REMARKS

This is a full and timely response to the outstanding non-final Office Action mailed May 4, 2005. The Examiner is thanked for the thorough examination of this application.

Claims 1, 4, 8, 10, 12, 21, 23, 30 and 32 have been amended. Claims 3, 11, 22, 23, and 31 have been cancelled. After entry of the foregoing amendments, claims 2, 5-7, 9, 13-20, 24-29, and 33-41 remain pending in this application. Moreover, Applicants have amended FIGs. 1 and 3 to add reference numerals 20 and 40. In view of the amended drawings, the objections to the drawings, and to the specification, are properly addressed and overcome.

FIG. 1 - Prior Art

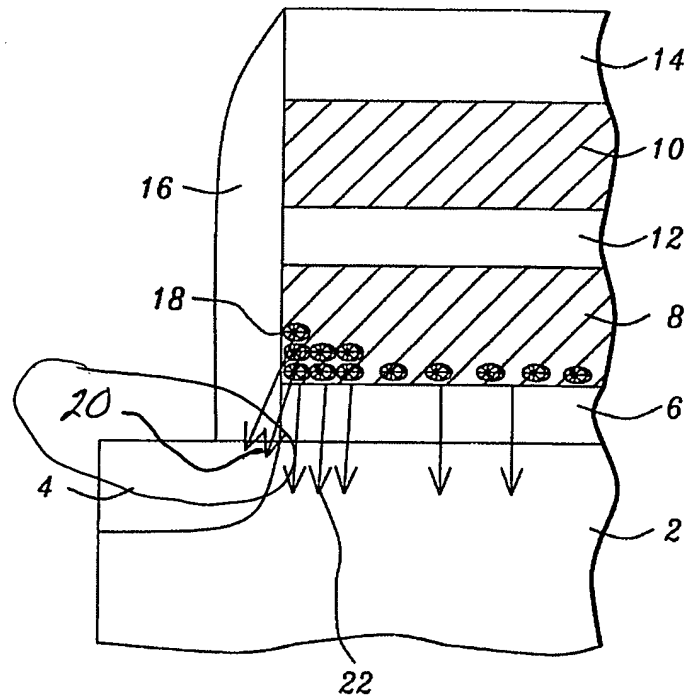
In FIG. 1, reference numeral 20 is added to designate the two arrow pointing down and to the left, as shown in the accompanying annotated sheet.

FIG. 3

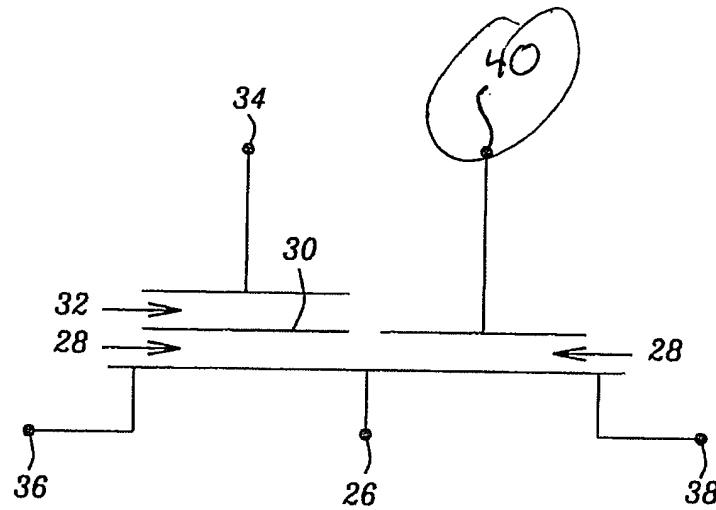
In FIG. 3, reference numeral 40 is added, as shown in the accompanying annotated sheet.
